Service Advisory: Coil Stop BBR Game: Oktoberfest

SA-12820

REASON: Reports of Beer Barrel Ramp shot being difficult to make. Testing indicates that shortening the flipper stroke increases odds of making the BBR shot.

P/N SUB0025-01
Longer coil stop insert

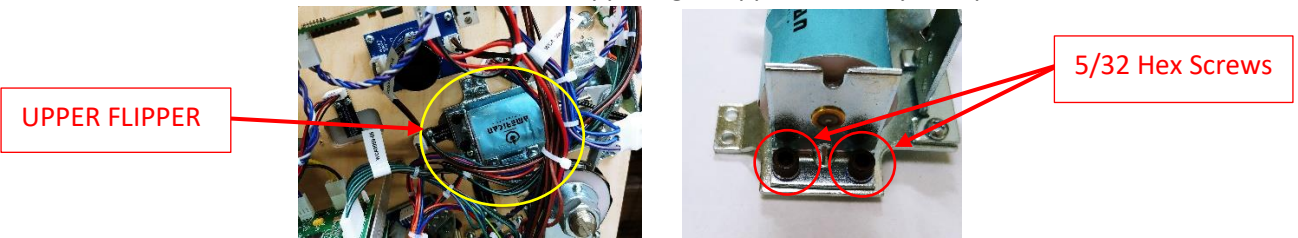
6. Remove the two 5/32 hex screws from the upper right flipper assembly. Swap the coil brackets.

7. Replace the 2 hex screws, *don't forget the lock washer on each screw.*
8. Install the playfield glass, lock down bar and close the coin door.
9. Plug the unit in and power up the game.
10. Test the game for as long as needed.
